RE: Summer Winds Major Cluster Subdivision; Master Plan Approval
4772 Old Post Road, Plat 7 Lot 51

At their special meeting of October 6, 2021, the Charlestown Planning Commission completed review of the master plan application for the proposed 36 lot major subdivision off Old Post Road also designed as a cluster subdivision. The Planning Commission voted 5 to 0 to approve the master plan submission for Summer Winds, prepared by Jackson Surveying, Inc. dated November 2020, revisions date of September 7, 2021, based on the findings of fact and conditions of approval, as listed below.

PROPOSED MASTER PLAN
SUMMER WINDS
 Lot 51 on AP 7 in Charlestown, RI
 Zoned Residential R-2

Sheet: **P1**

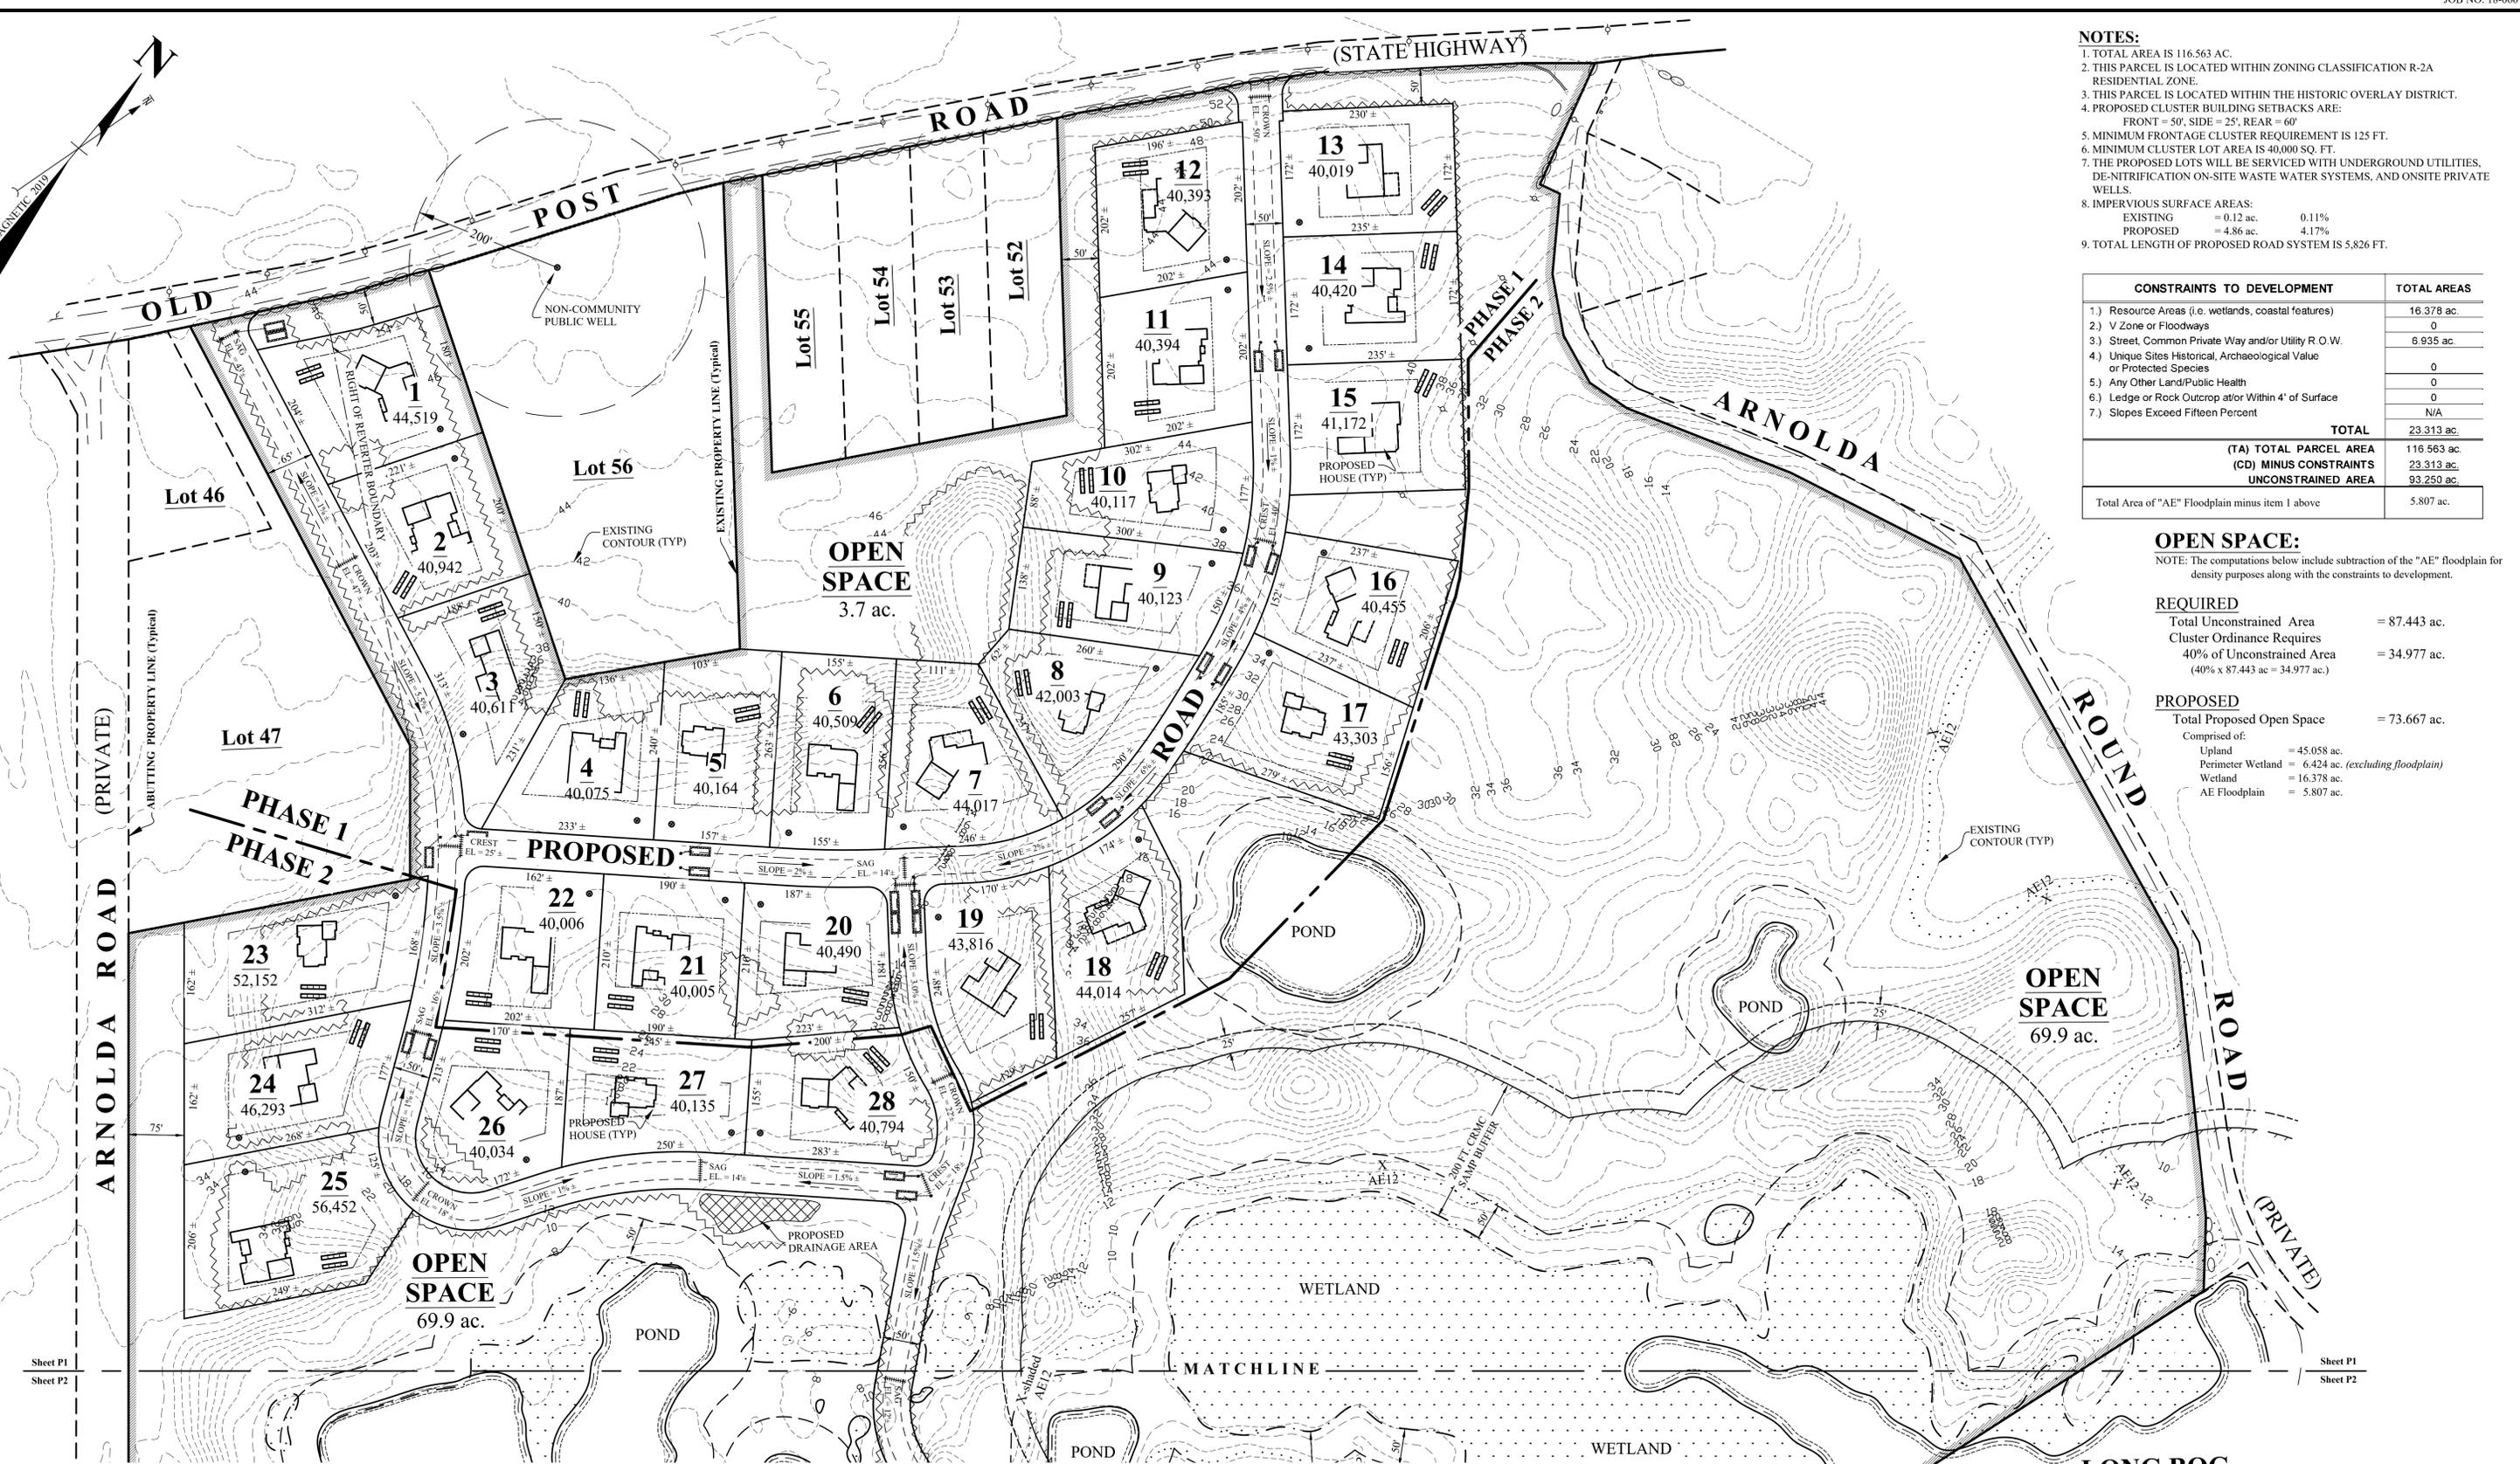
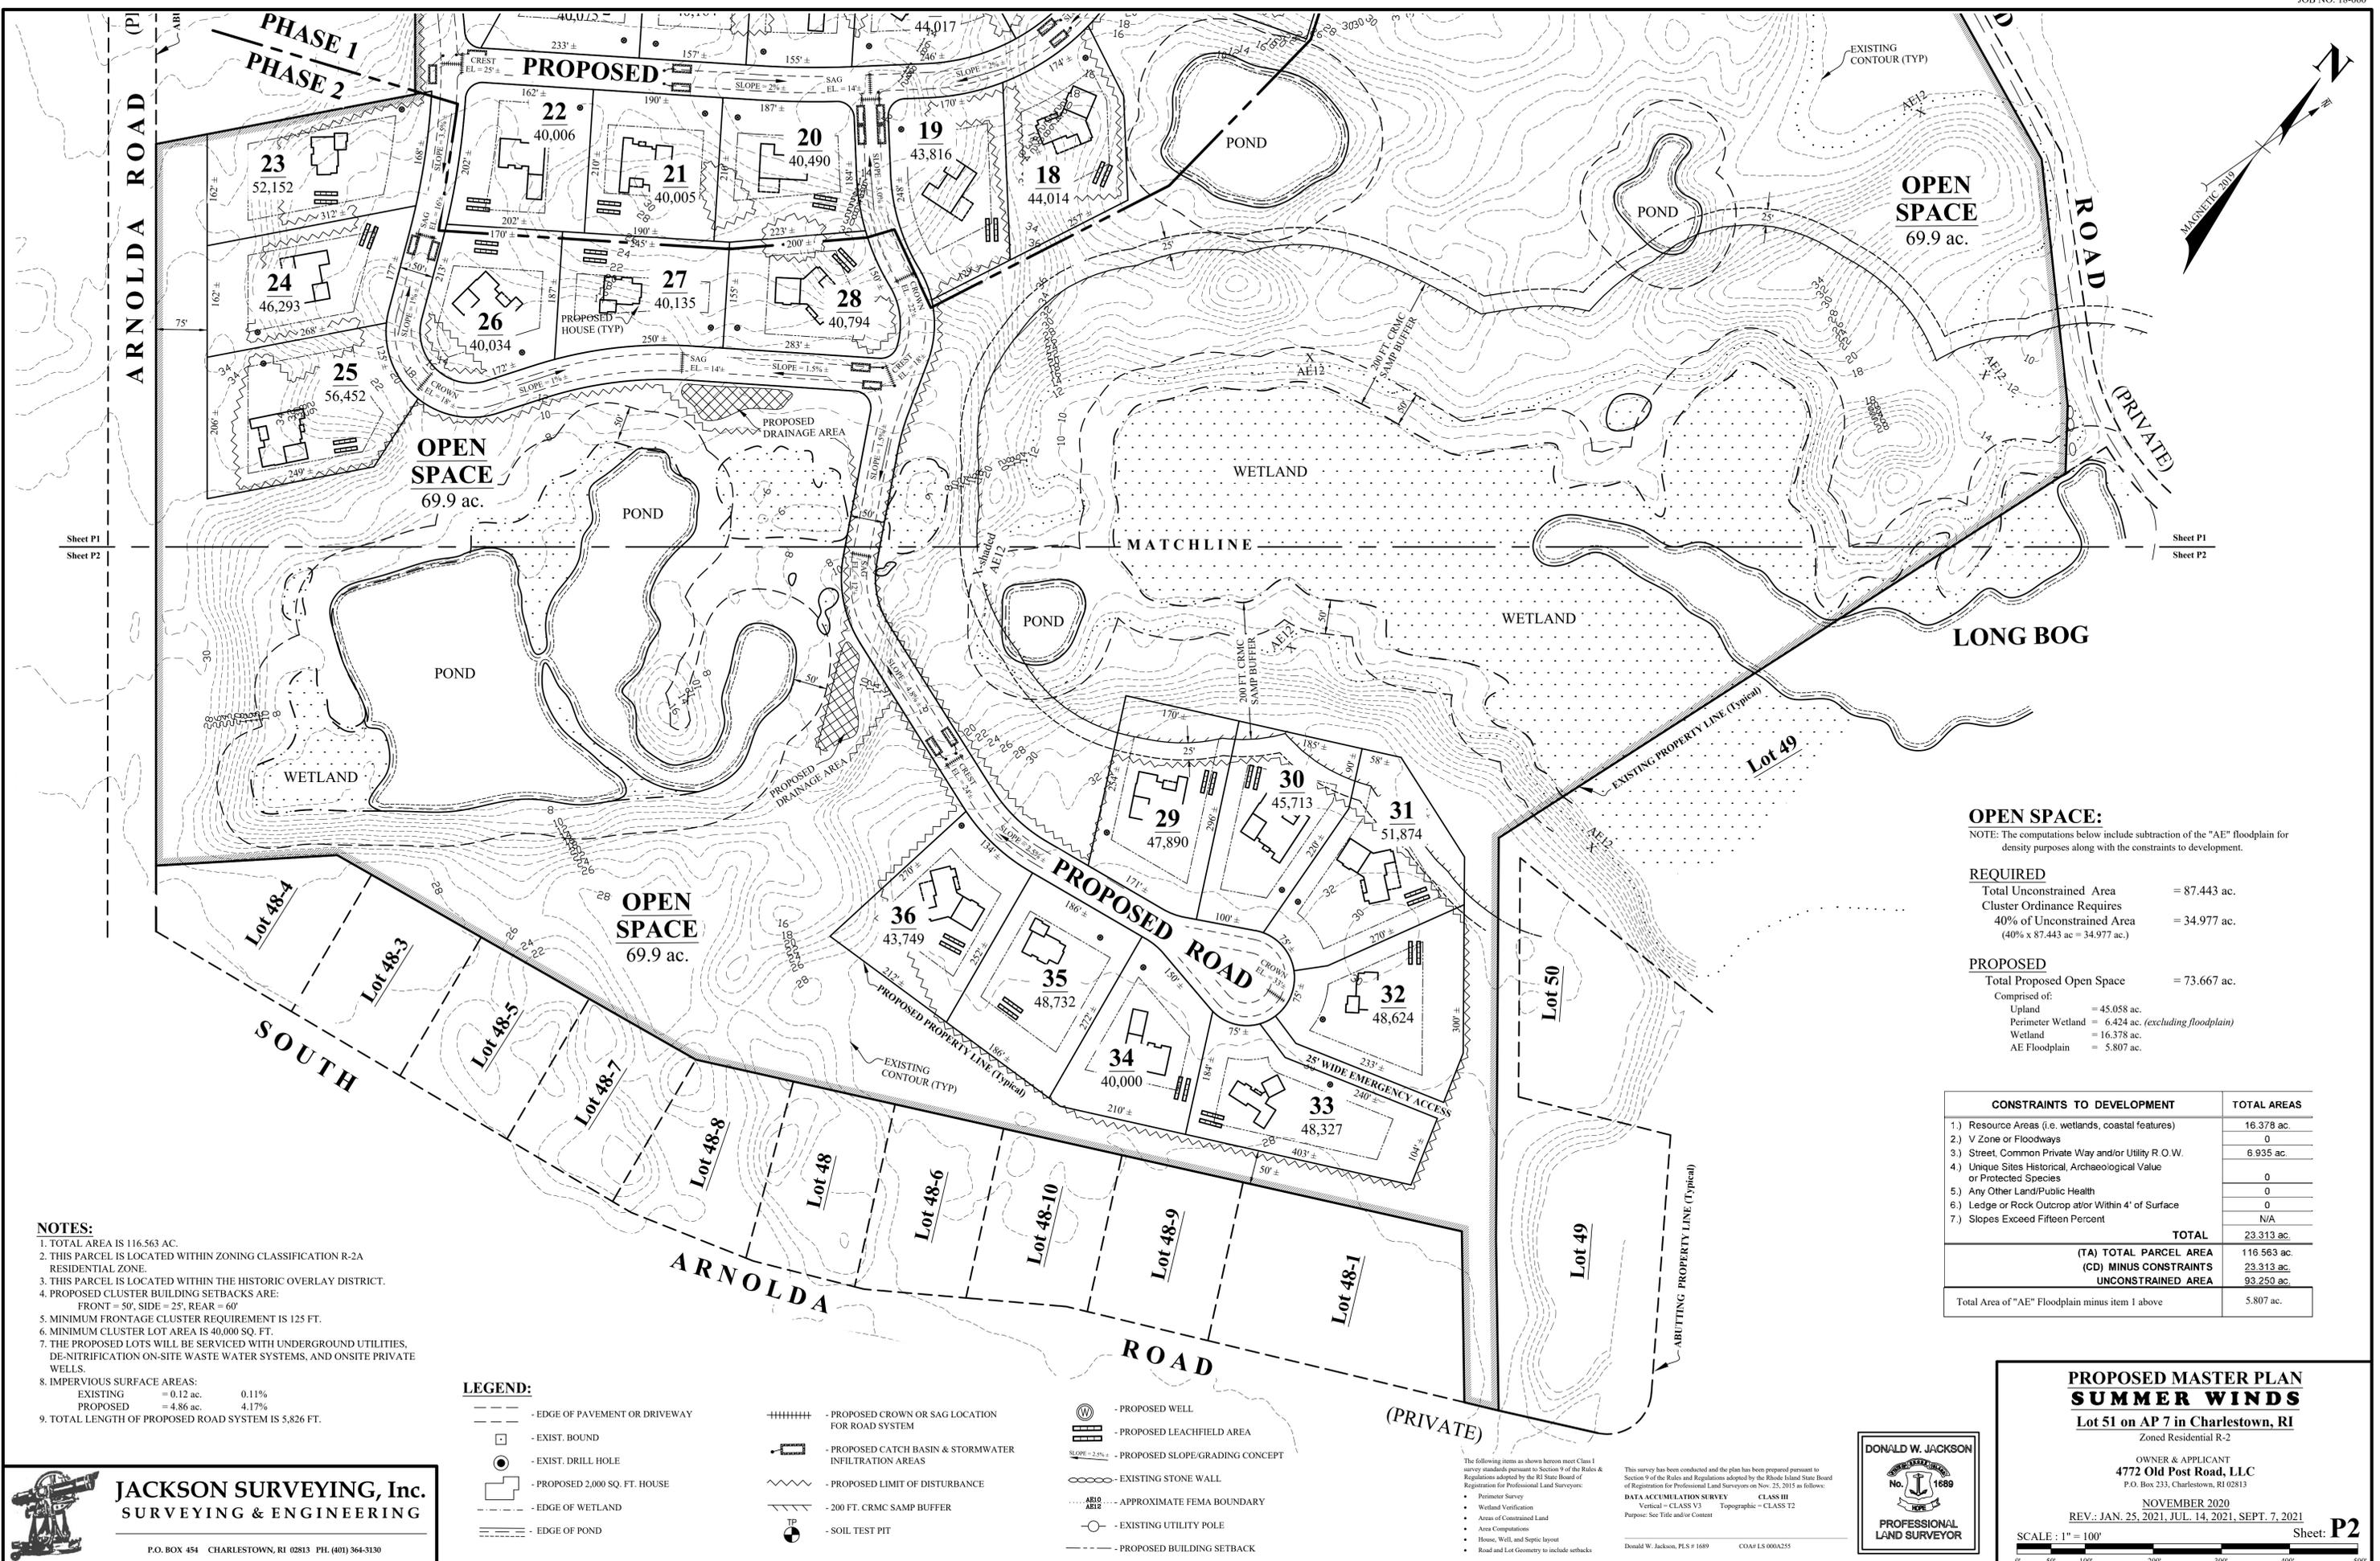
1. The dimensions of Plat 7 Lot 47, including final lot area and road frontage, shall be included on the preliminary and final plans for Summer Winds;
2. The emergency road access shown at the end of the cul-de-sac in the southern field shall be removed from the preliminary and final plans for Summer Winds;

3. There shall be an updated open space plan submitted at the preliminary plan phase that shows in shading, with total areas included, of all upland used in the calculation of the protected open space, for visualization and management plan purposes, and confirmation that the protected open space remains in compliance with the cluster ordinance;

4. The landscaping plans shall include a staggered row of large evergreen trees in the proposed fifty-foot buffer between the new development and the lots bordering on South Arnolda Road, and similar buffering with evergreen trees shall be provided to screen other residential lots adjacent to the subdivision, including Plat 7 Lots 49 and 50, and any other lot that is not fully screened by existing natural vegetation;
